**Request for Qualifications (RFQ)
Architectural Services for Roof and Parking Lot Project**

Request for Qualifications (RFQ) Addendum
Architectural Services for Roof and Parking Lot Project

Released July 7, 2025

Appendix D

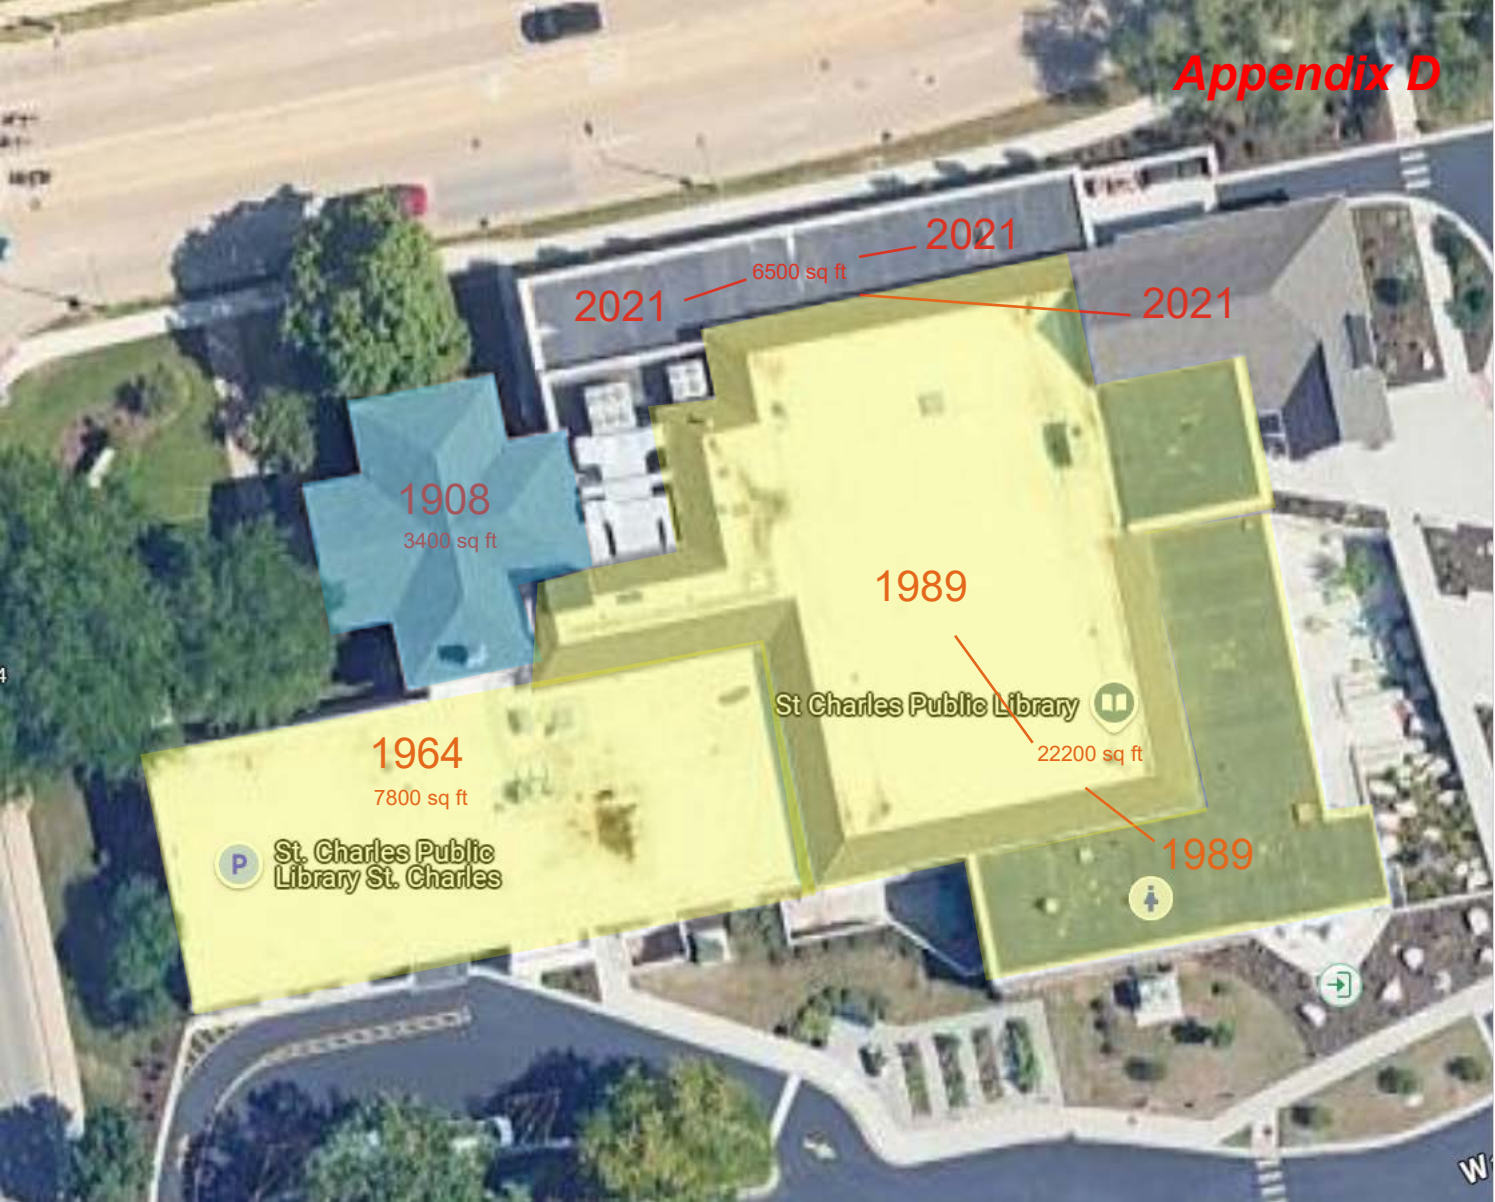
4. Can you highlight what areas of the roof are to be included in the scope (on the image included in the RFQ). The RFQ says primarily Carnegie but others were discussed on the tour.

Answer: Please see Appendix D which is a replica of Appendix B, but it includes the requested highlighting of the roof. The Carnegie roof is highlighted in blue and the rest of the older sections are highlighted in yellow. We will rely on the roof assessment to determine when the other areas will need replacement.

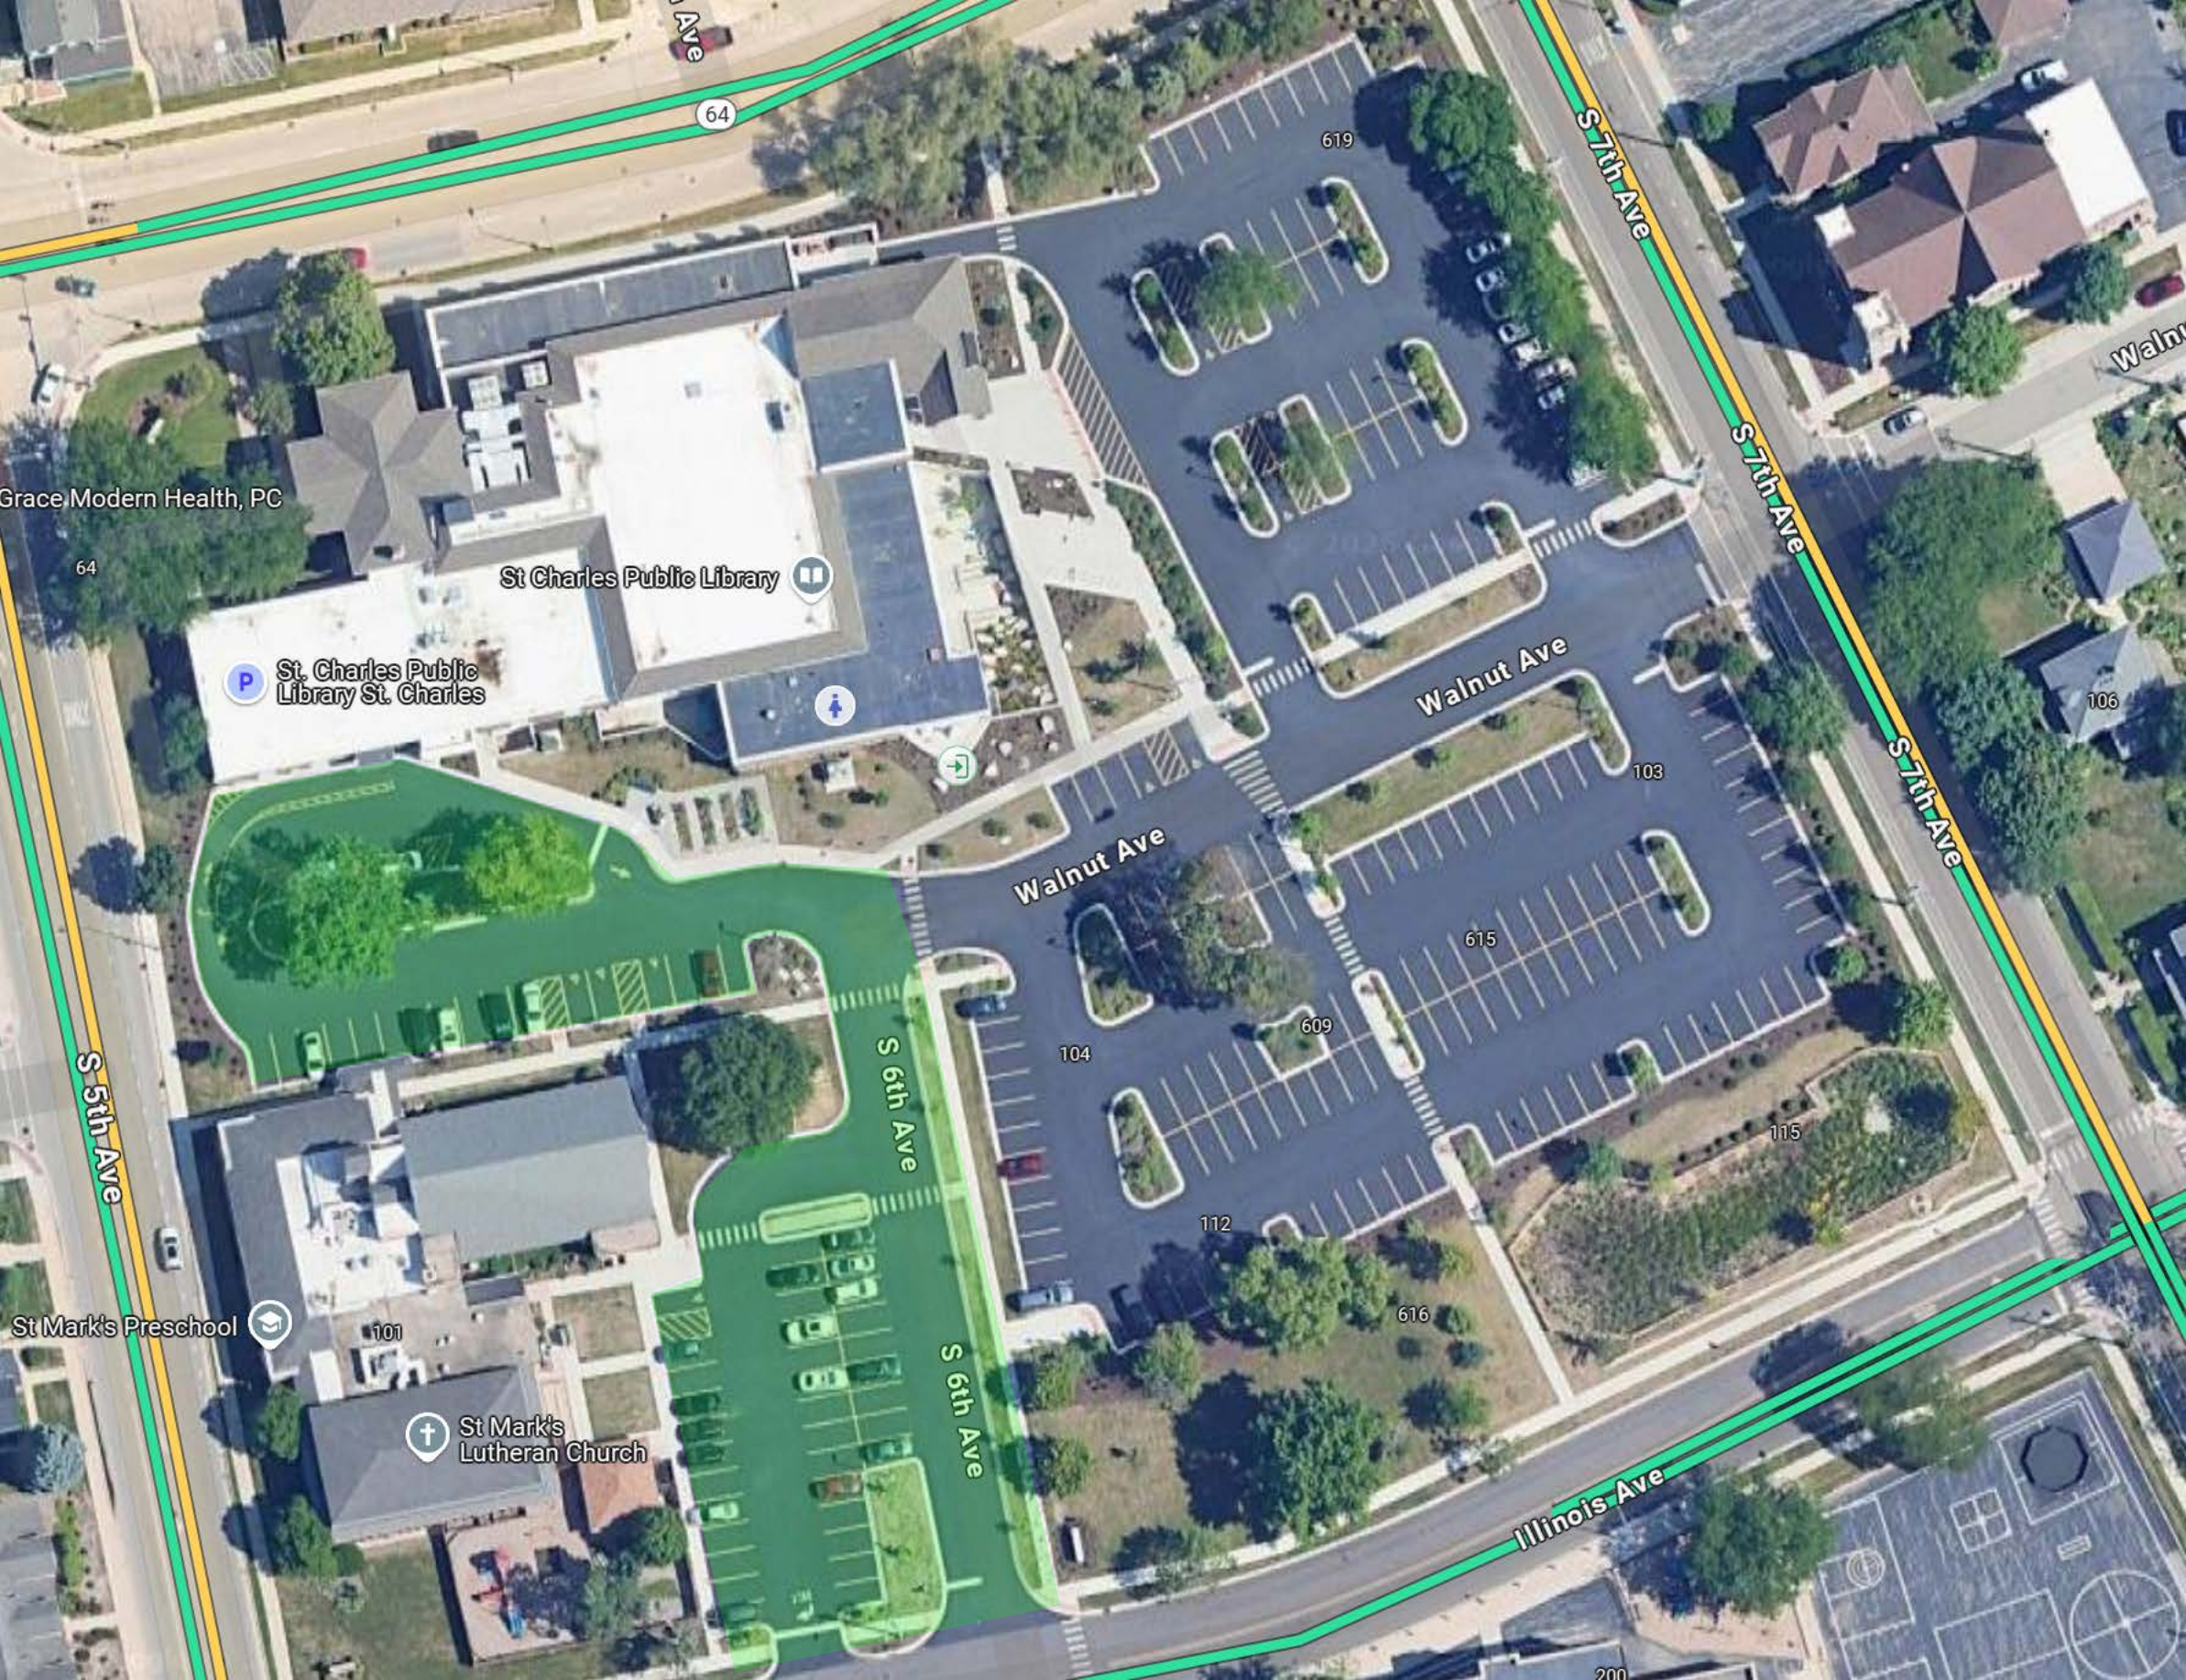
5. I have included an image of the site. Could you highlight the areas of Shared Parking to be included in the scope please?

Answer: Please see Appendix E. Image attached shows all shared parking lot areas to be included.
